Technical Service Bulletin

Topic	High pitched whistle from the engine - Warning light within the DIP - Engine not running smoothly - Numerous DTC's
Market area	Bentley: worldwide (2WBE),China 796 VW Import Comp. Ltd (Vico), Beijing (6796)
Brand	Bentley
Transaction No.	2075922/3
Level	EH
Status	Released for publishing
Release date	Dec 10, 2025

Figure 2

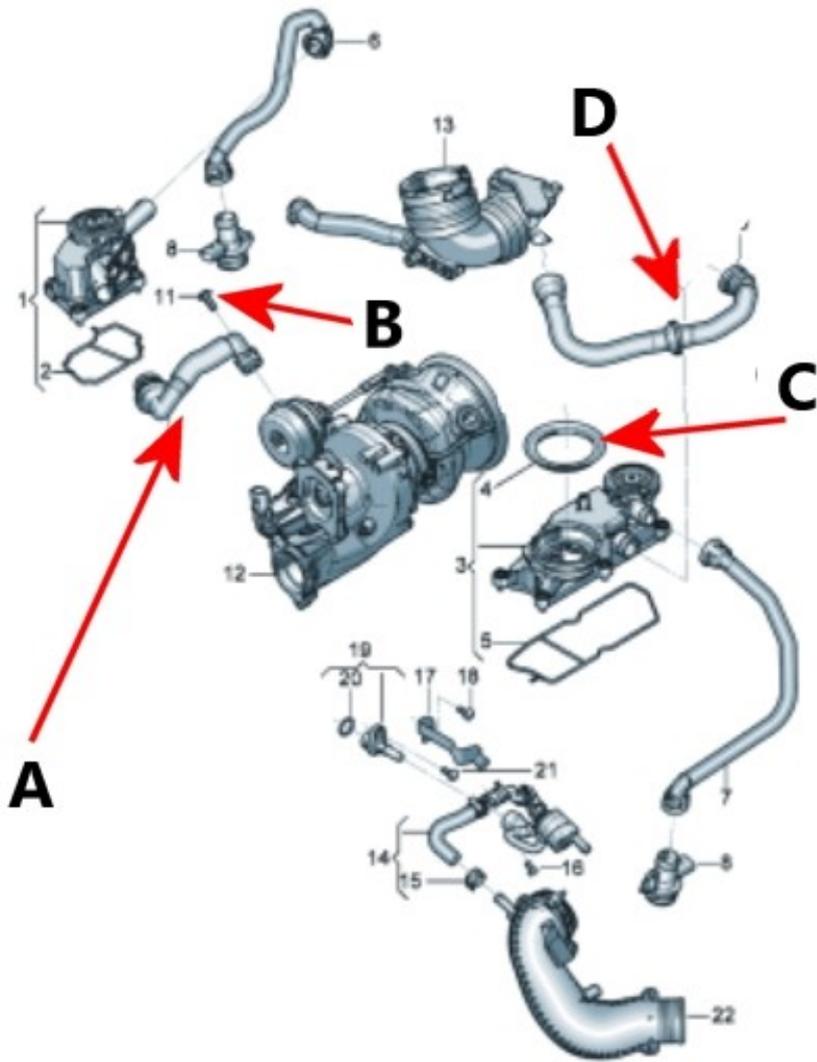
2) Referring to Figure 2 - Replace the following:

- Bank 1 Breather line (Point A) and fixing (Point B) - Refer to applicable sections from Rep.Gr 10 - Oil mist separator bank 1 - To remove and fit
- Replace the oil filler pipe seal to the Bank 2 oil separator (Point C)
- Replace the Bank 2 Breather line (Point D) - Refer to applicable sections from Rep.Gr 10 - Oil mist separator bank 1 - To remove and fit

Figure 3

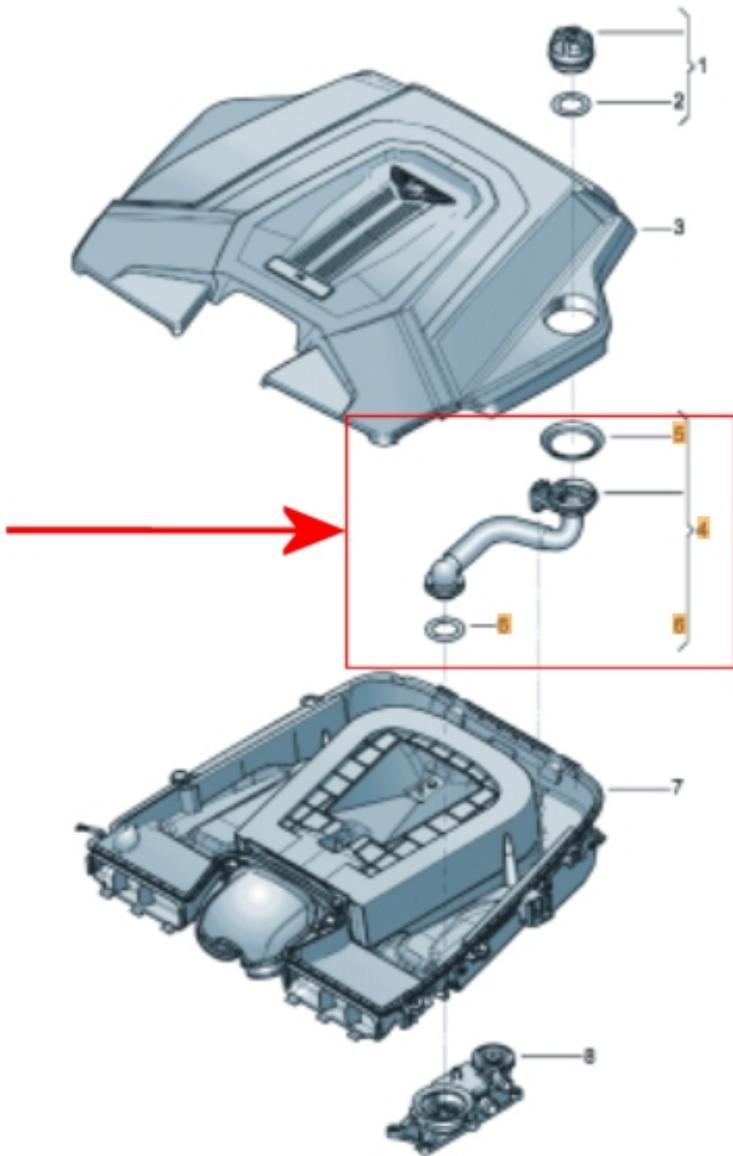
Replace the oil filler pipe including all seals (Figure 3) - Refer to applicable sections from Rep.Gr 10 - Oil mist separator bank 2 - To remove and fit
